Appendix H – Stakeholder Comments on Updated PSP

FirstLight Hydro Generating Company
Turners Falls Hydroelectric Project, FERC No. 1889
Northfield Mountain Pumped Storage Project, FERC No. 2485

This responds to the updated Proposed Study Plan (PSP) submitted by FirstLight Hydro Generating Company (FirstLight) on June 28, 2013 as part of the relicensing of the Turners Falls and Northfield Mountain Pumped Storage (NMPS) projects, located on the Connecticut River in Franklin County, Massachusetts.

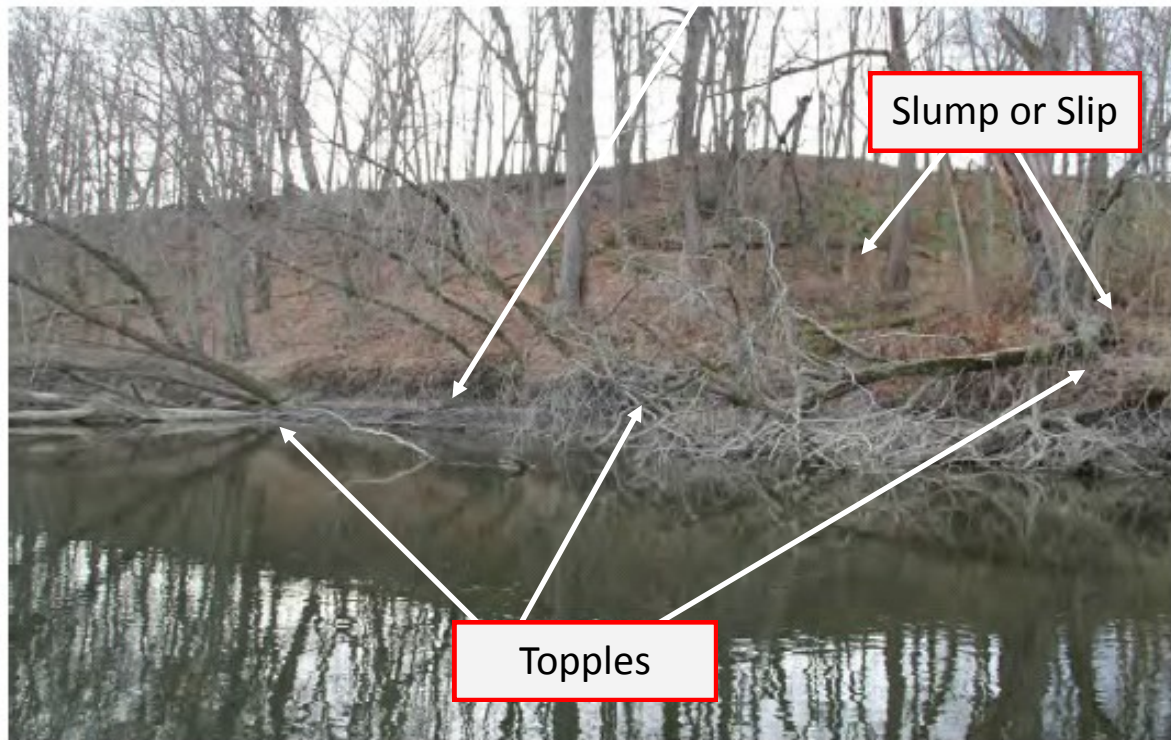
TEXT, TEXT BOXES AND ARROWS on the following pages that IDENTIFY THE TYPE AND STAGE OF EROSION after Field (2007) ADDED BY FRCOG 7-15-13.

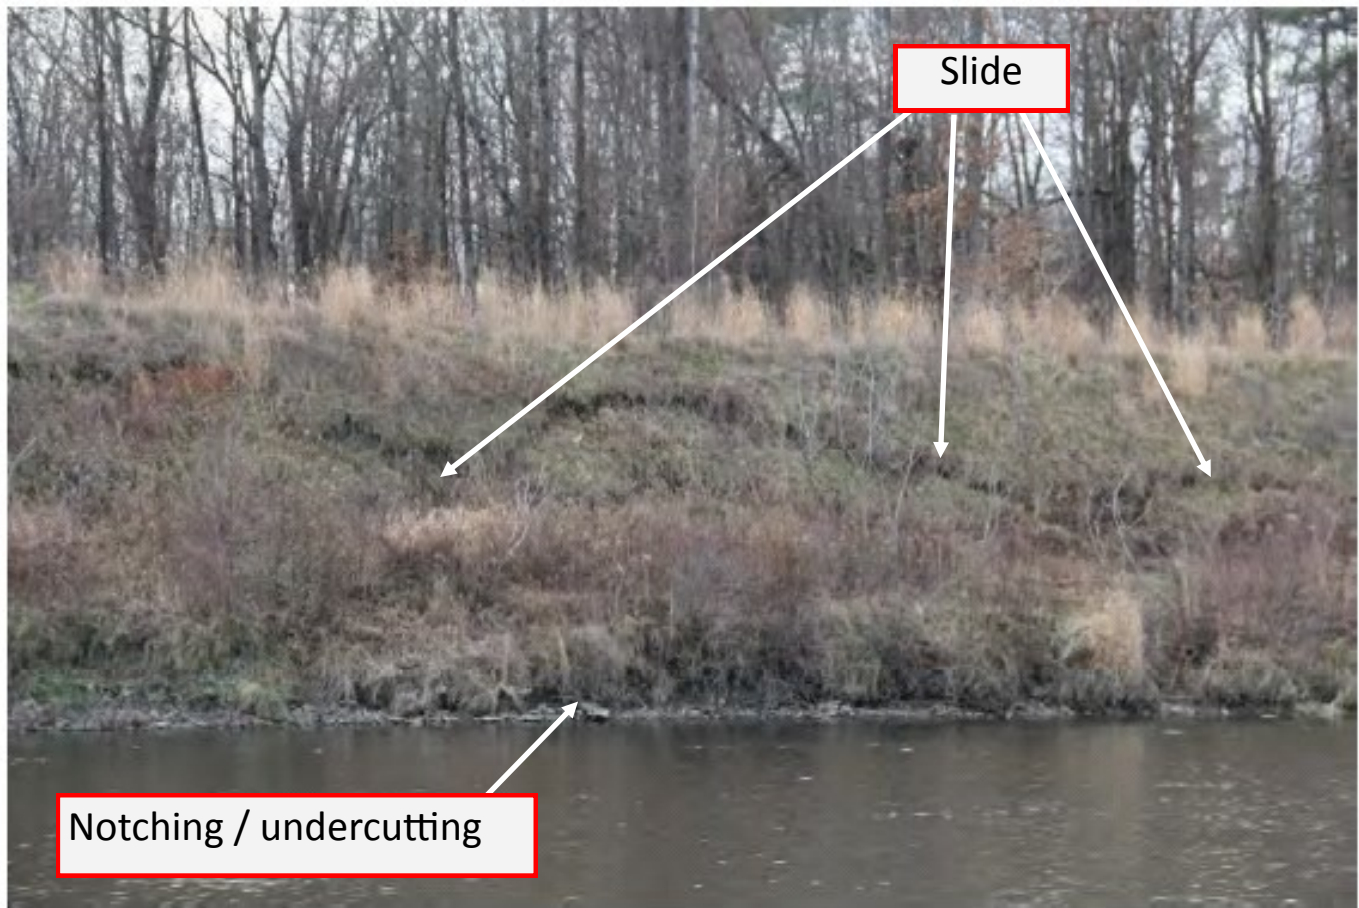
Stage of Erosion: b and c
Erosion Type: Falls (undercuts, gullies), Topples, Slides (slump, slip)

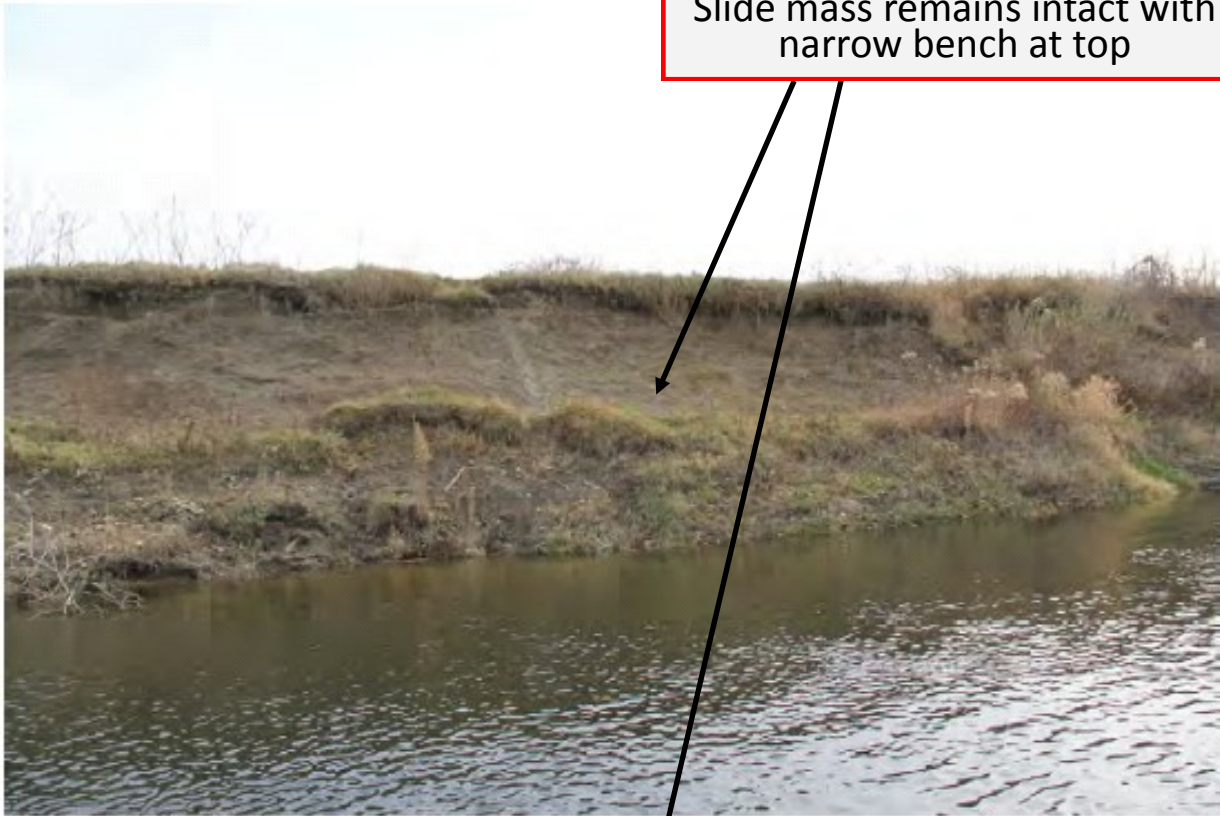
Stage of Erosion: b and c
Erosion Type: Falls (notching, undercutting)
Slides (planar slip)

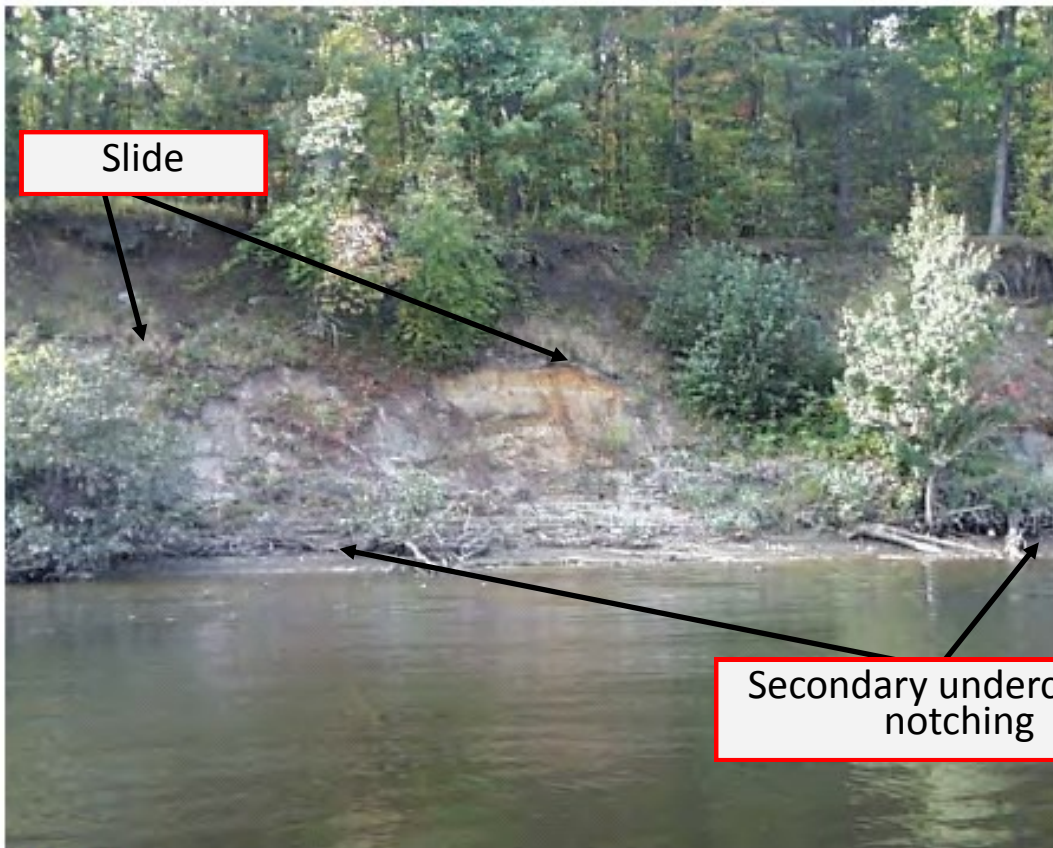
Stage of Erosion: b and c — Slide mass remains intact with narrow bench at top
